NP-11-0011
April 12, 2011

Subject: Exelon Nuclear Texas Holdings, LLC
Victoria County Station Early Site Permit Application
Response to Request for Additional Information Letter No. 05
NRC Docket No. 52-042

Attached are responses to NRC staff questions included in Request for Additional Information (RAI) Letter No. 05, dated March 14, 2011, related to Early Site Permit Application (ESPA), Part 2, Sections 02.02.03, 13.03, and 14.03.10. This submittal comprises a complete response to RAI Letter No. 05, and includes responses to the following Questions:

Figure 12: Evacuation Map and Routes

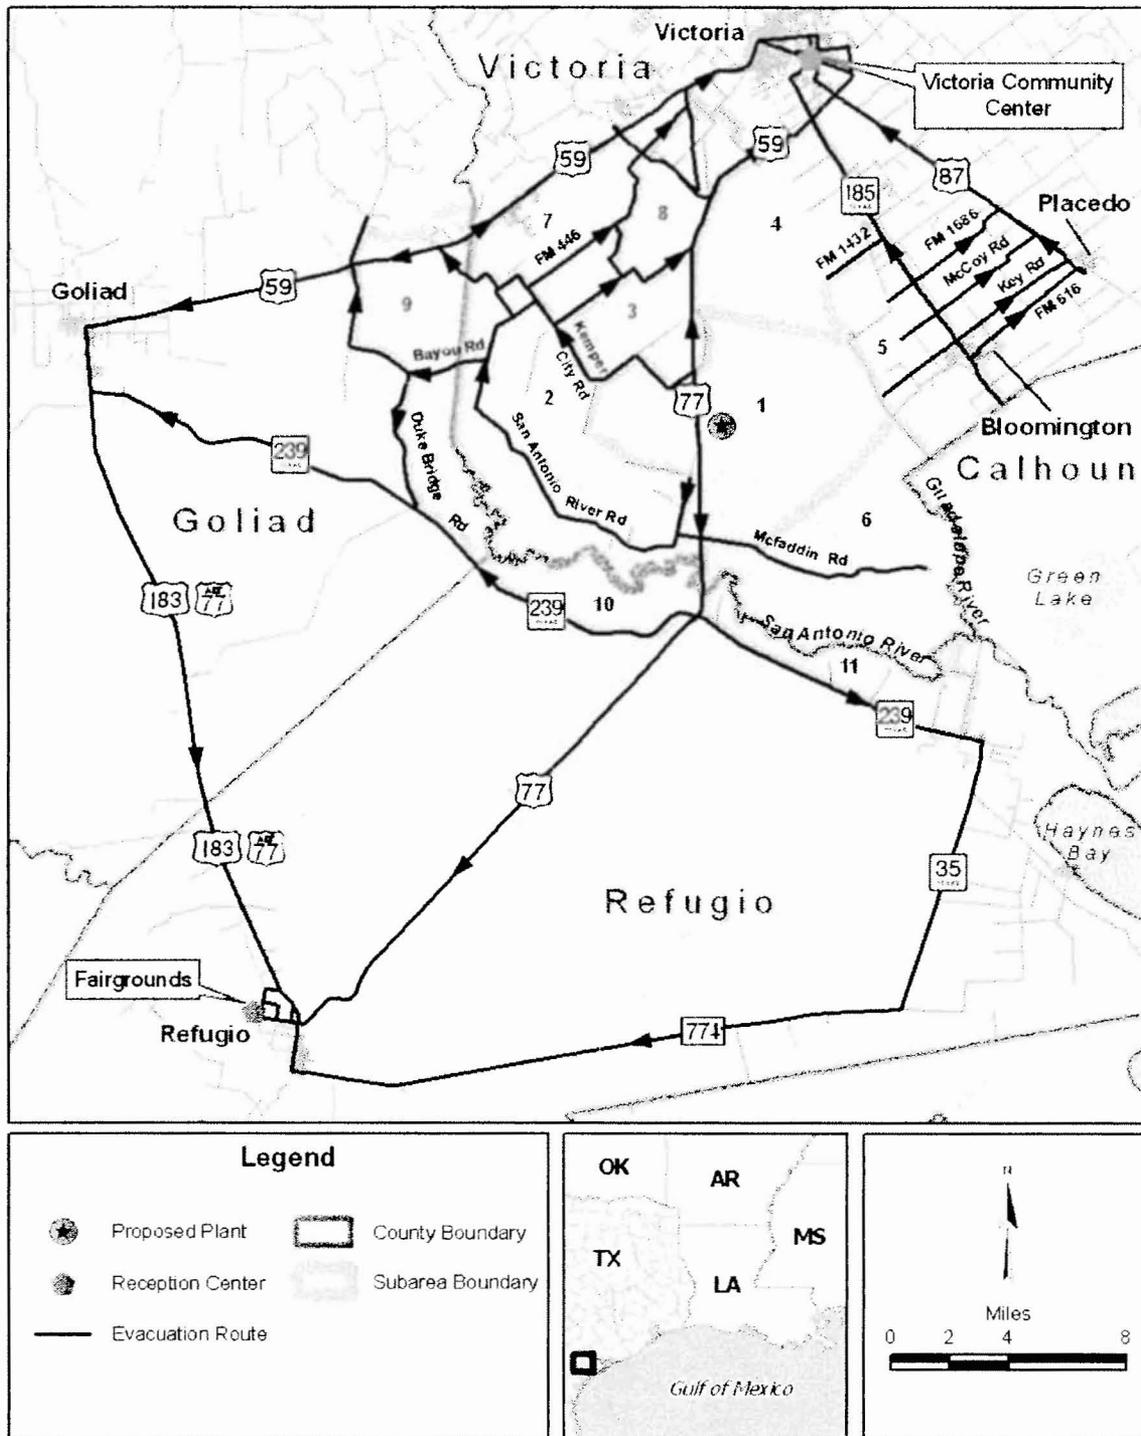
US Highway 77 is identified as an evacuation route in Figure 12, "Evacuation Map and Routes," traversing through the entire EPZ in a northern to southern direction indicating a length of about 20 miles. US Highway 77 is identified in Appendix B, "Evacuation Network Links," as having a length of 6.3 miles. In the ETE Report, discuss why the full length of US Highway 77 was not used in the analysis.

In figure 12, the location where US Highway 77 intersects with US Highway 59 indicates an intersection and a left turn required for travelers to access US Highway 77 to continue north. Aerial mapping shows this intersection to be non-signalized and a free flow under the East Frontage Road (State Road 91) with uninterrupted flow on US Highway 77 in the northerly direction. Discuss in the ETE Report how the crossing of US Highway 77 and US Highway 59 was analyzed.

Appendix B of the ETE report has been revised to incorporate the correct full length of US Highway 77 that comprised part of the evacuation network and was included in the model. The revised ETE Report is provided in Attachment 34.

Figure 14: Evacuation Events and Activity Series for Residences without Family Members Returning Home (Series B)

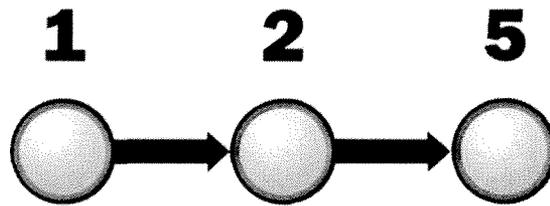
Section 5.1.1, "Trip Generation Events and Activities," states "Figure 14 shows the approach for estimating trip generation for different evacuation activities series." Explain whether this should read "Table 12" rather than "Figure 14" and revise the ETE Report if necessary.

The referenced statement should read "Table 12" and not "Figure 14."

The reference to "Figure 14" has been changed to "Table 12" in Section 5.1.1 of the revised ETE report. The revised ETE Report is provided in Attachment 34.

Figure 16: Notification Times for Selected Alert and Notification Systems³¹

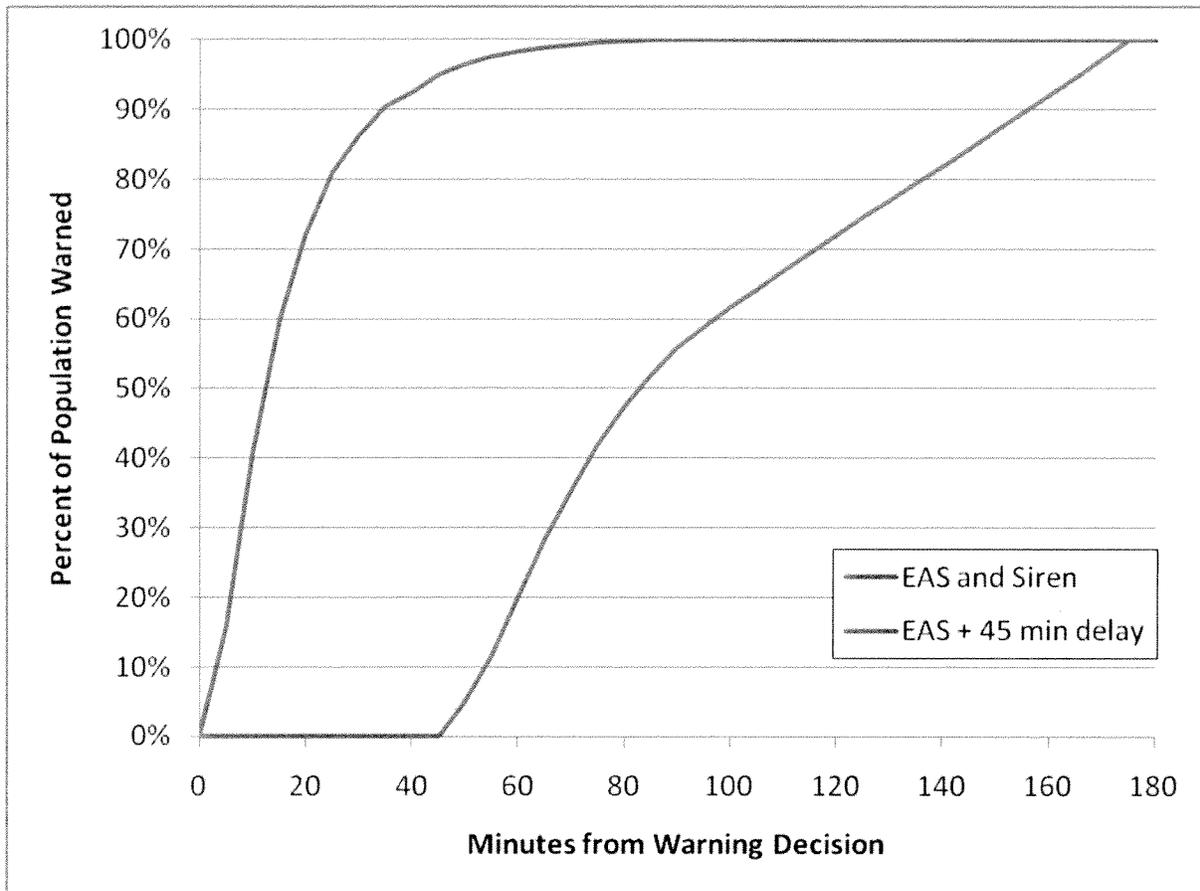
Section 5.1.2, "Trip Generation time Estimate," explains that the time distribution for notification presented in "Evaluating Protective Actions for Chemical Agent Emergencies," (ORNL-6615) was adopted for the ETE study and is presented in Figure 16, "Notification Times for Selected Alert and Notification Systems." In the ORNL-6615 study, Figure 3.4, "Probability of Receiving Warning by Warning System by Time Elapsed Since Warning Decision," shows similar, but not the same information, as Figure 16. For instance, Figure 16 provides data for the combination of EAS and siren systems; whereas, Figure 3.4 provides data for EAS or siren systems, but does not combine the data. Explain how Figure 16 was derived from the ORNL-6615 study to present a distribution of warning time for the combined use of EAS and siren.

The sirens curve was removed from Figure 16 in the ETE report as the distribution was no longer used in the ETE study. However, for completeness, the notification time distribution used for recreational populations (EAS plus 45 minutes) was added to the figure. Figure 16 now includes both notification distributions used in the model.

Figure 22: Map of Evacuation Network Links (from Table 21)

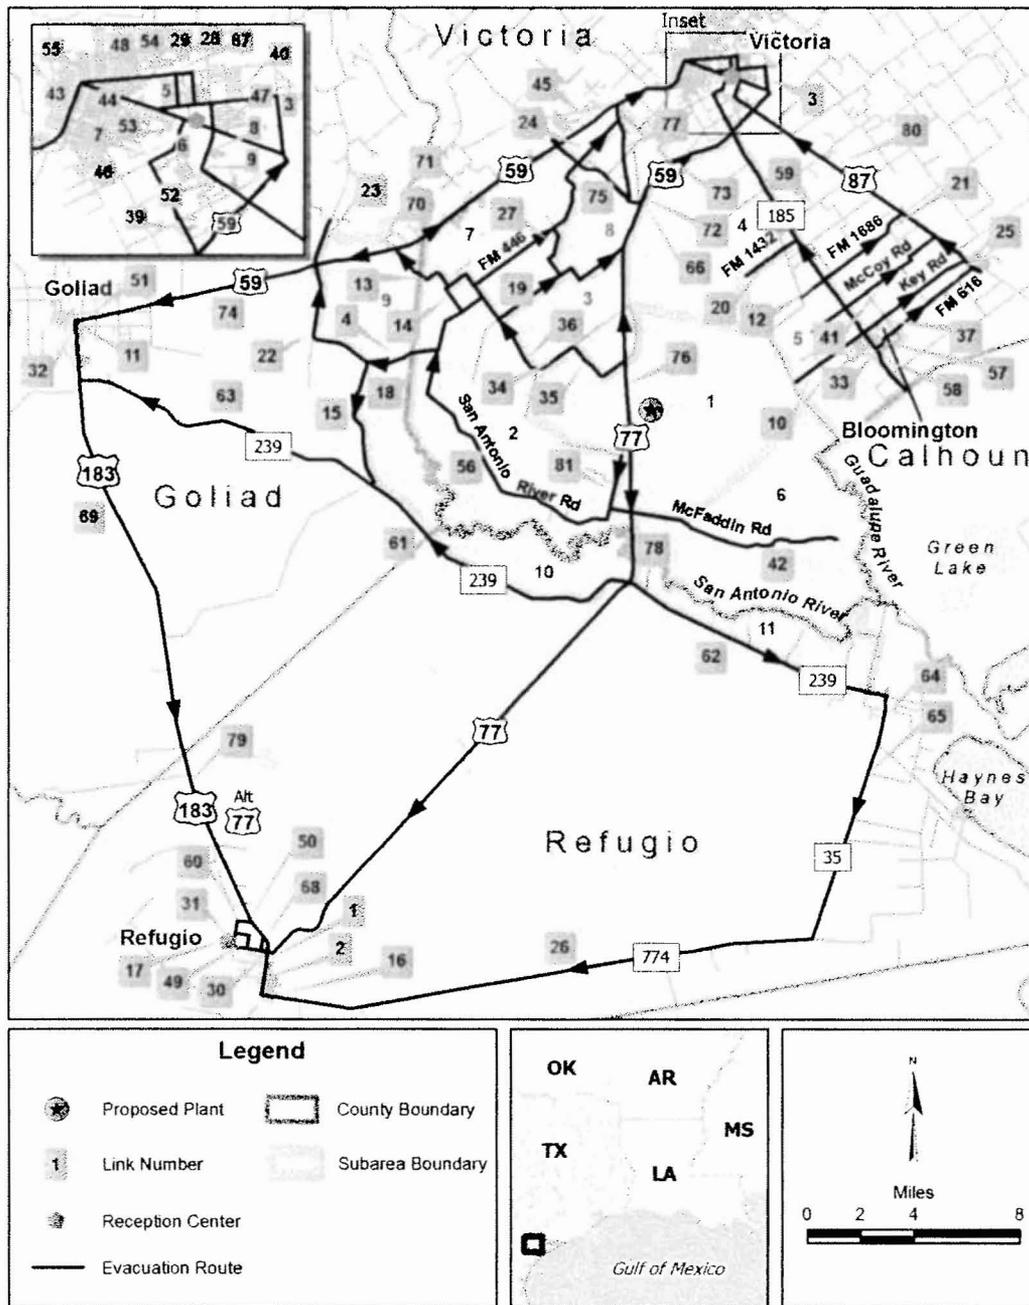
Appendix B, "Evacuation Network Links," lists all of the roadways used as evacuation routes and identifies the number of lanes, length, and speed limit for each roadway segment. In the ETE Report, provide an annotated map of the roadway nodal network that relates to Appendix B roadway segments.

Appendix B of the ETE report has been revised to include an annotated map of the roadway network (see Figure 22).

Appendix B of the ETE report has been revised to include an annotated map of the roadway network (see Figure 22). The revised ETE Report is provided in Attachment 34.
